APPEAL SUMMARY

Appeal ID: 16167	Project Address: 7118 N Vancouver Ave
Hearing Date: 11/22/17	Appellant Name: Tom Jaleski
Case No.: B-017	Appellant Phone: 5034885651
Appeal Type: Building	Plans Examiner/Inspector: Tara Carlson
Project Type: residential	Stories: 3 Occupancy: Townhouses Construction Type: V-B
Building/Business Name:	Fire Sprinklers: No
Appeal Involves: Erection of a new structure	LUR or Permit Application No.: 17-237878-CO
Plan Submitted Option: pdf [File 1]	Proposed use: Townhouses

ORIGAMI
PERMIT SET
JUNE 15, 2017

ORIGAMI

SITE PLAN

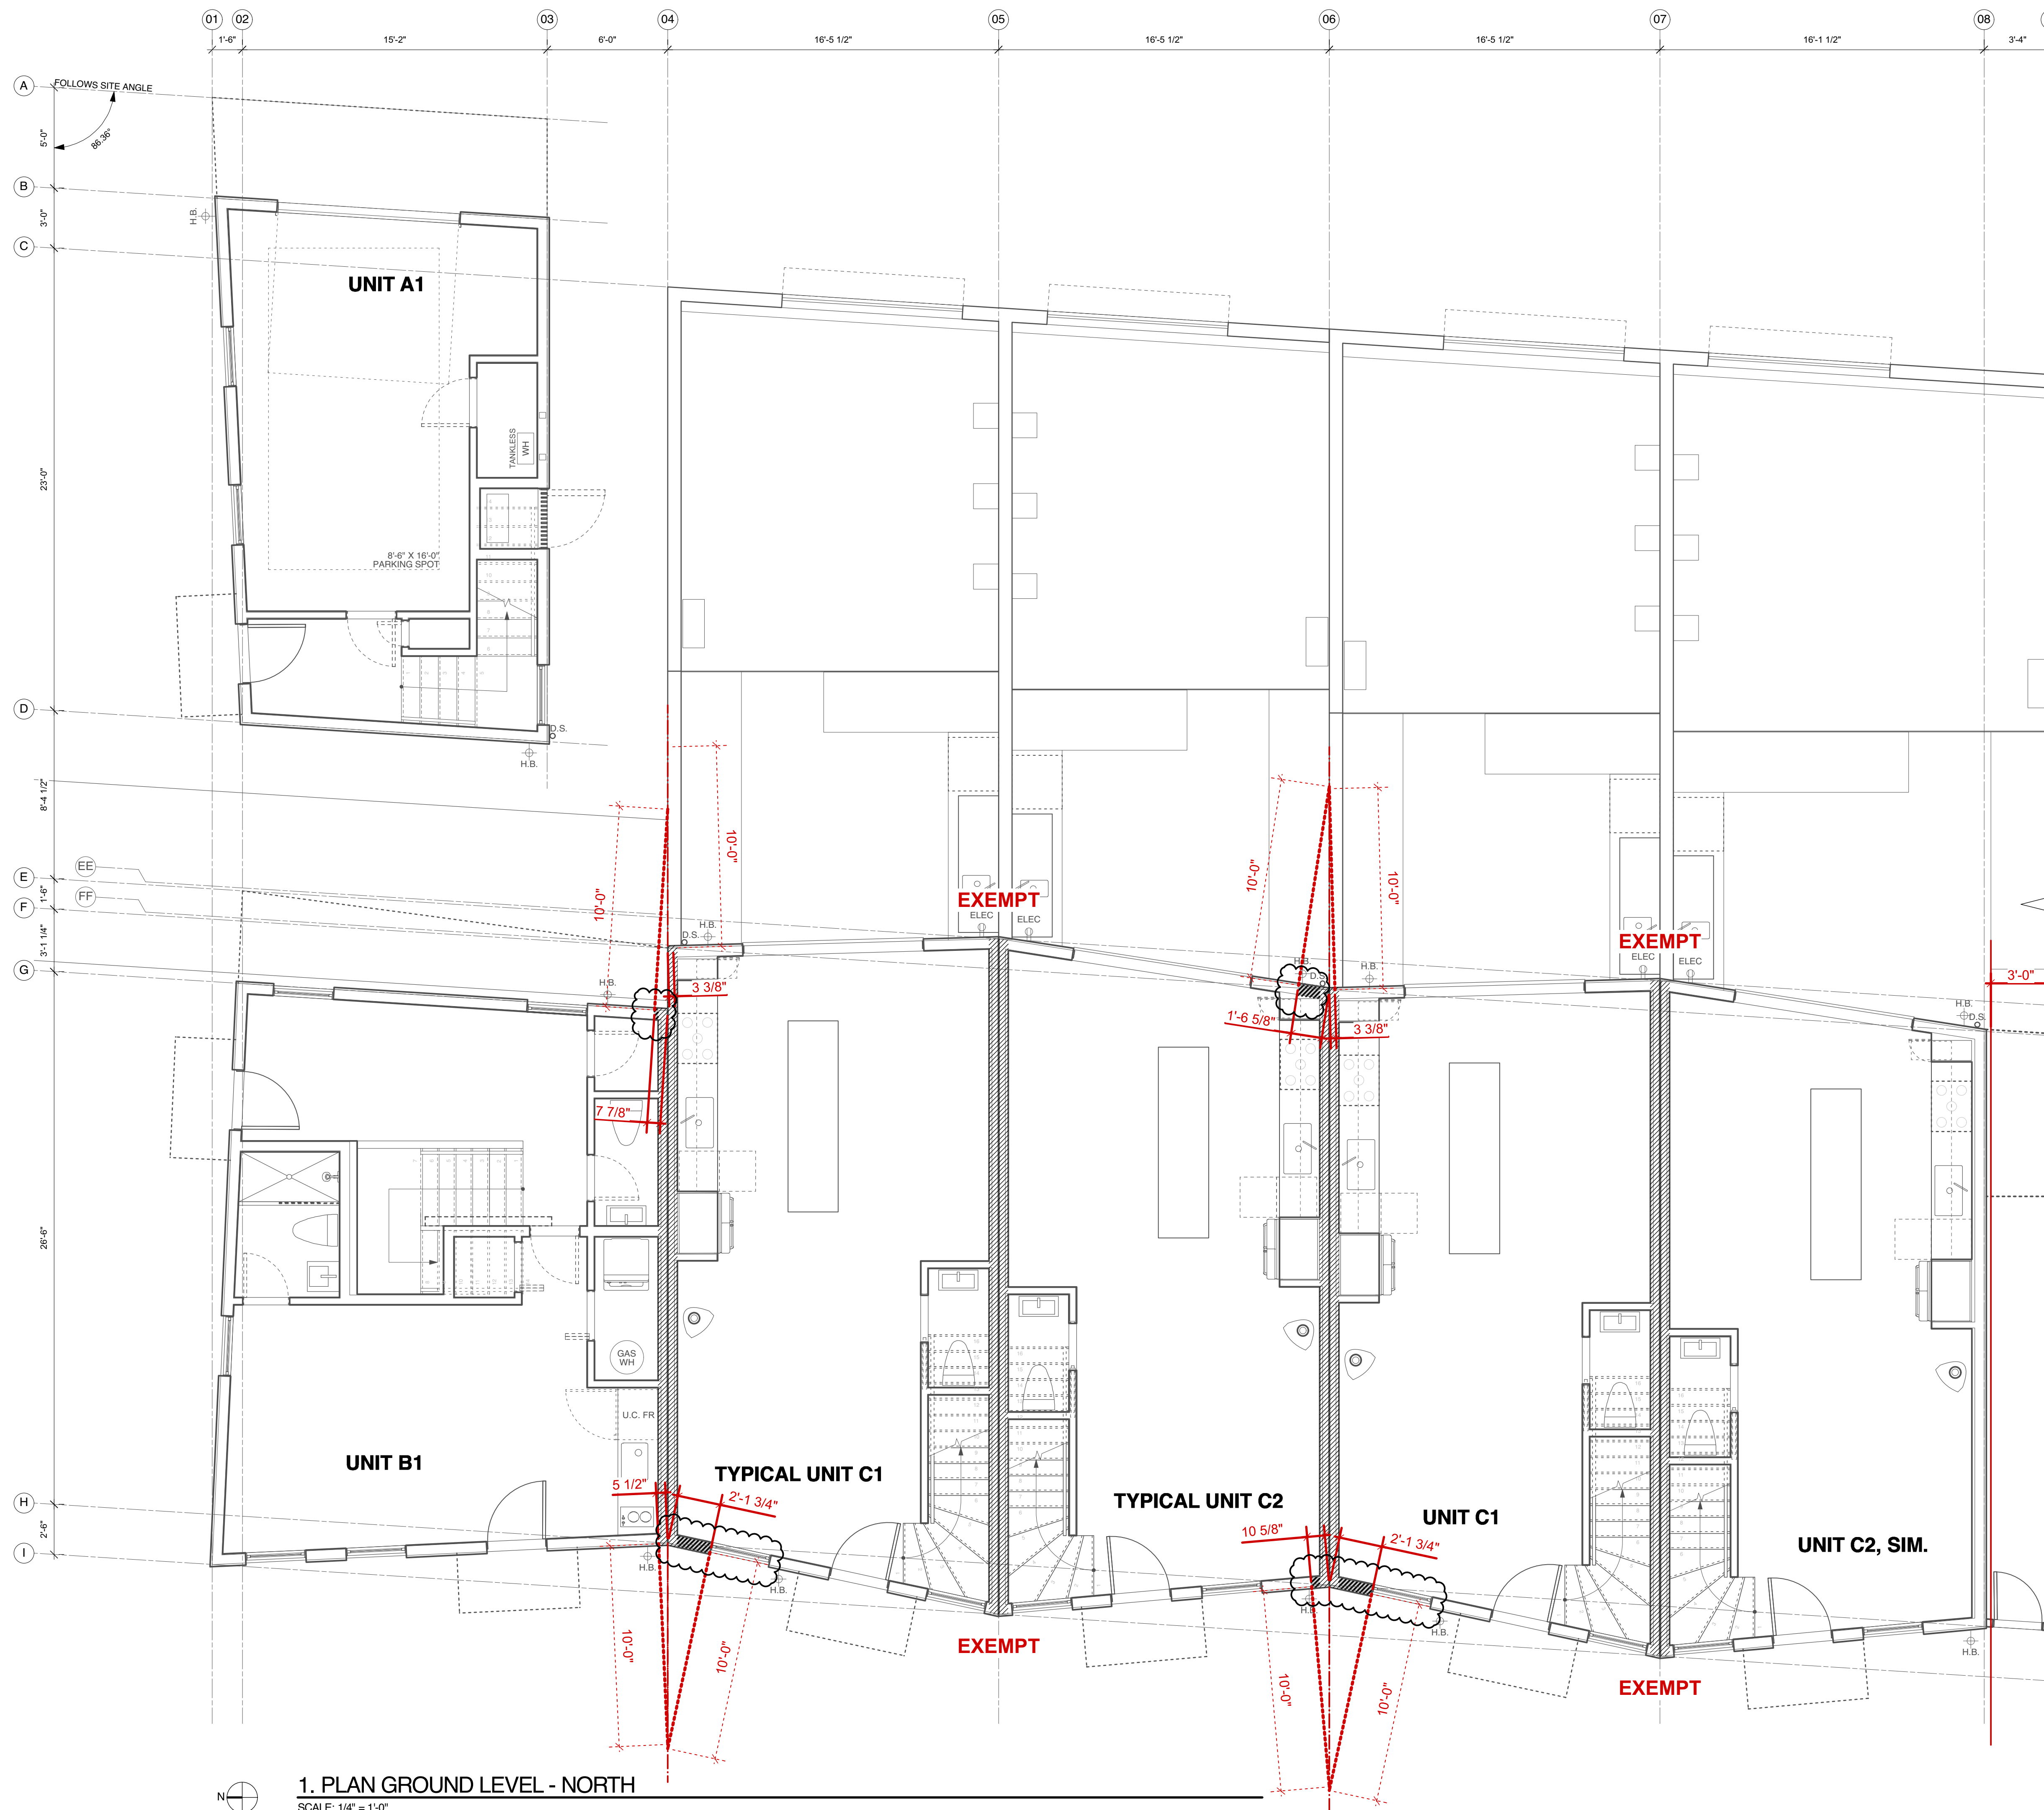
Proposed Design The proposed design for lots 2, 3, 4, 5, 7, 8, 9, 10, and 12 of the Origami Townhouses where windows on the exterior walls are less than 3 feet from the common property line and the walls are less than perpendicular to the common property line are as follows:
The fixed windows will have a fire separation distance of at least 10 feet to the common property line, exceeding the requirement of Table R302.1.
The walls within 3 feet on either side of the common property line will have a 1 hour rated assembly with non-combustible siding.

Reason for alternative The Origami townhouses are of Type VB construction and not sprinklered, as allowed per ORSC R302.2.5. The townhouses will meet the requirements of 2014 ORSC except that there are unprotected windows within 3 feet of the common property lines where the walls are less than perpendicular to the common property line.

The proposed design is to provide 1 hour rated walls with non-combustible siding on the exterior walls and have the windows located so that the fire separation distance to the common property line is at least 10 feet. 2014 ORSC Table R302.1 allows unlimited quantity of unprotected windows where the fire separation distance is only 3 feet, much less than our proposed design. The walls where the windows are located have angles less than perpendicular, but greater than 70 degrees, and allows windows near the common property lines to have a fire separation distance of 10 feet to the common property line. The fire separation distance is defined in R202 as the distance from the building face at a right angle, to the closest lot line. The fire separation distance of the windows in the proposed design, as shown on the attached plans, is at least 10 feet from the edge of the window closest to the common property line. The exterior walls are 1 hour rated exterior wall assemblies as required per R302.2.6.1 with the additional protection of non-combustible siding. These assemblies will mitigate the potential for fire and smoke spread between townhouses. ORSC R302.2.6 and R302.2.7 are meant to prevent the spread of fire and smoke between townhouses where the walls are less than 90 degrees to the common property line. These code sections do not address the varying degrees of wall angle to the common property line. The code section is roughly based on testing by NIST in Technical Note 1600, attached, where parallel walls are tested with a fire separation distance of 3 feet. The openings in the test are directly in line with each other and the test shows that the window in the adjacent unit did not break until the temperature reached 1000 degrees Fahrenheit (560 C). The openings in the proposed design are oriented less than 15 degrees from perpendicular to the common property line and provide additional protection against the migration of fire and smoke between windows by having a fire separation distance of at least 10 feet. Table R302.1 allows unprotected openings with a fire separation distance of more than 3 feet. This is consistent with the NIST test where it showed that windows lined up and 6 feet from each other. The proposed design greatly exceeds the tested conditions in relation to angle between the openings and fire separation distance. The additional protection measure provided of fire separation distances of at least 10 feet, greatly exceeds the requirements of R302.1 and provides equivalent protection for the openings to not be impacted by a fire/smoke event in an adjacent townhouse.

Measurement of fire separation distance where wall openings are not perpendicular to the common property line: Granted as proposed with one hour exterior walls rated for exposure to fire from the inside and non combustible siding.
